SERVICE BULLETIN

Classification: HA16-004	Reference: NTB16-112	Date: November 15, 2016
-----------------------------	-------------------------	----------------------------

2013-2014 ALTIMA; A/C DOES NOT BLOW COLD AND CLUTCH DOES NOT ENGAGE

APPLIED VEHICLE: 2013-2014 Altima Sedan (L33)

Figure 4

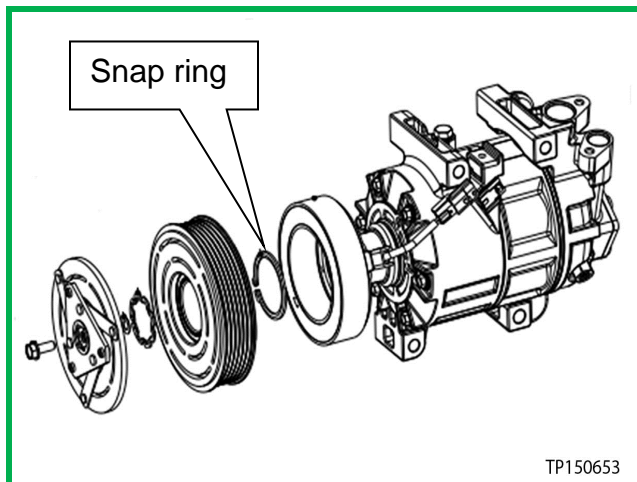
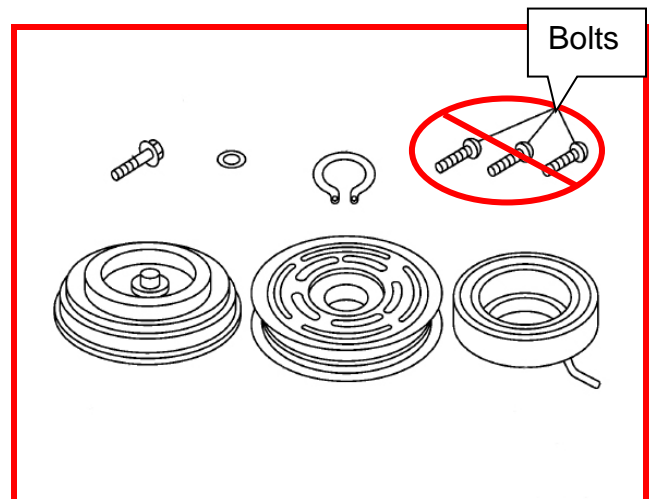
- The magnet coil for the applied vehicles is retained by a single snap ring as shown in Figure 4.
- Figure 5 (and illustrated in the ESM) is incorrect for the applied vehicles. The magnet coil is not attached by three bolts.

NOTE: The magnet coil, snap rings and bolt come with the CLUTCH COIL ASSY-COMPRESSOR (see **PARTS INFORMATION**).

- **Do NOT reuse the bolt or snap rings.**
